01-RF-00716  
JLB-009-01

**Draft Final  
Industrial Area  
Sampling and Analysis Plan**

**March 2001**

Comments from January 12, 2001	Response
1	Page 2, Section 1.1 – This section and this document need to be more specific about how this SAP fits into the integration of functions (characterization, remediation, and closure) that occur in an accelerated action.	A diagram (Figure 2) has been added to illustrate how the IASAP and other IA Strategy elements correlate with the accelerated action process.
2	<p>Page 3, Section 1.3 –</p> <p>A) Any addenda to this SAP must be reviewed and approved by the regulatory agencies. We recognize due to the cyclical nature of the DQO's that multiple rounds of sampling may be conducted under a SAP Addendum. Once an addendum is approved it may be appropriate to work on a concurrence basis for the follow-up rounds of sampling. It is not clear how data will be reported to the agencies. The State and the site should discuss details of how real-time data used for decision making will be provided to the regulators.</p> <p>B) RFETS submitted revised language on this section, our comments on that revision are:</p> <ol style="list-style-type: none"> <li>1.

**Figure 15**  
**AOC Determination**

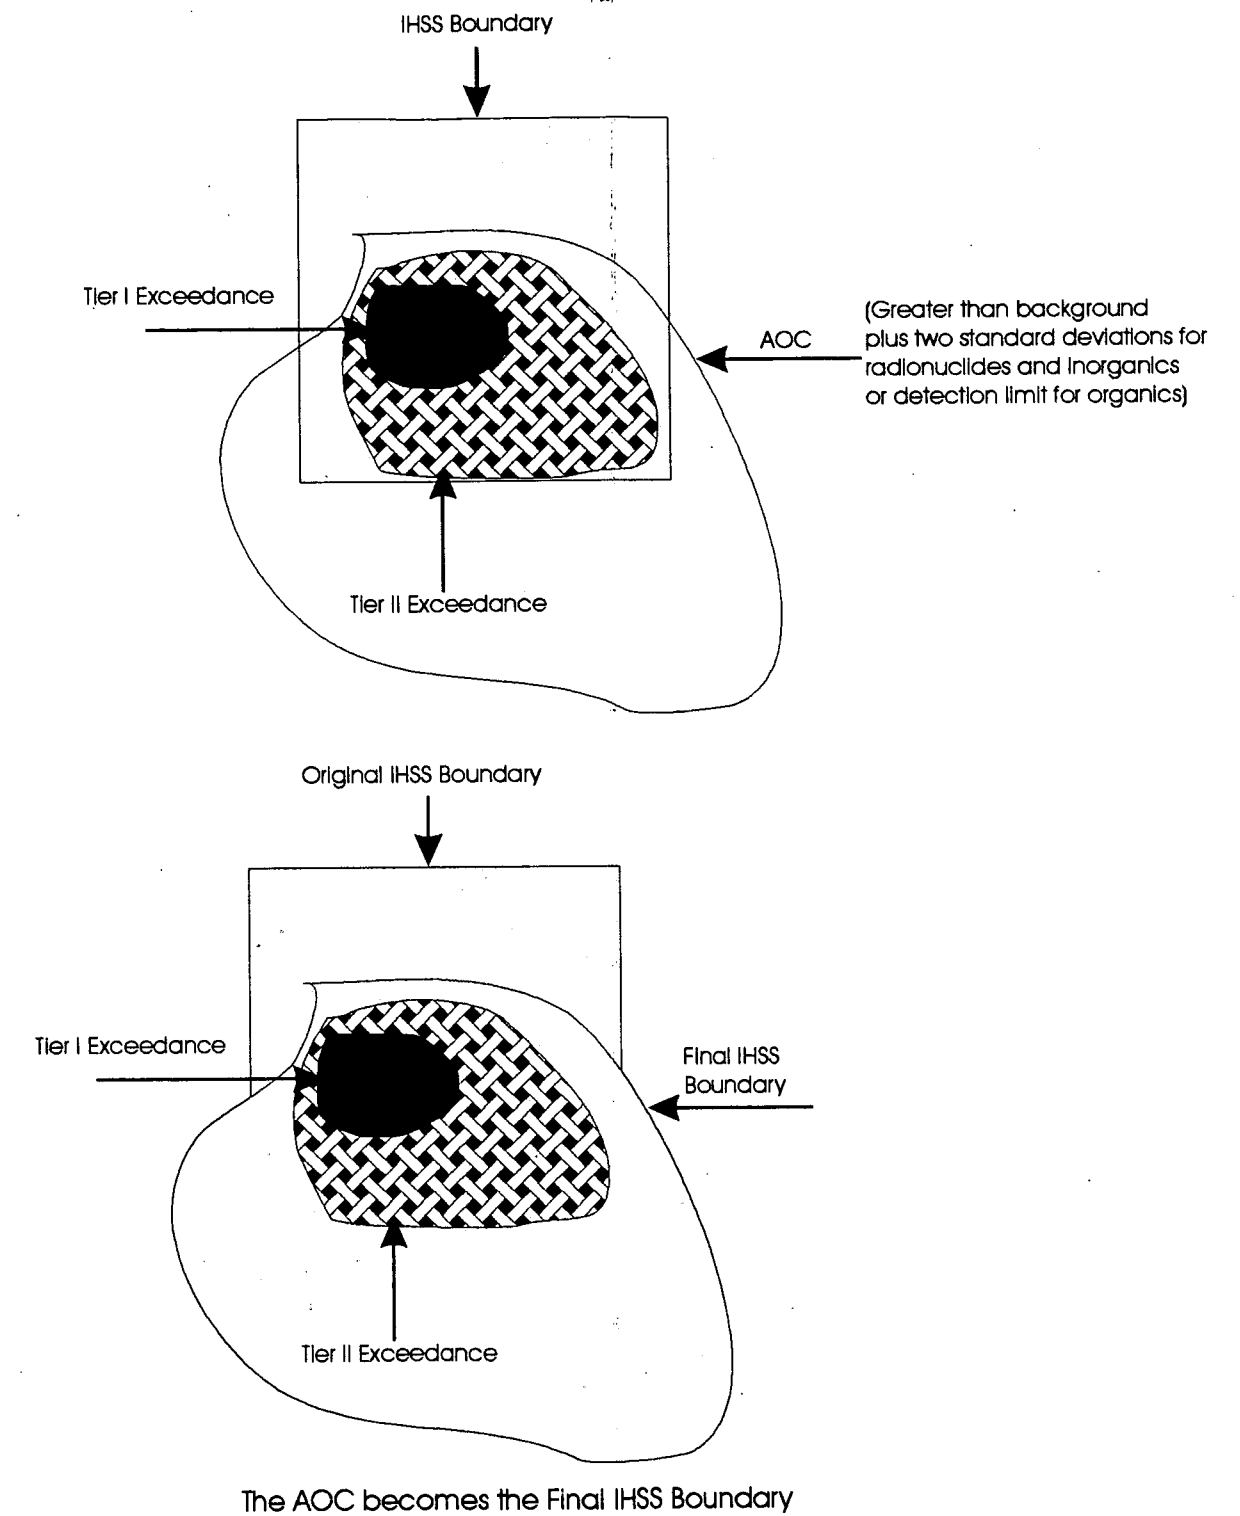
30	Figure 15 - It isn't clear why the initial input (blue box) is limited to "characterization sample analytical results". Won't confirmation sampling, plus any characterization sampling for areas where no remediation was necessary be the inputs here? Most of the characterization sampling	The initial input box has been changed to include existing analytical data as well as confirmation data.
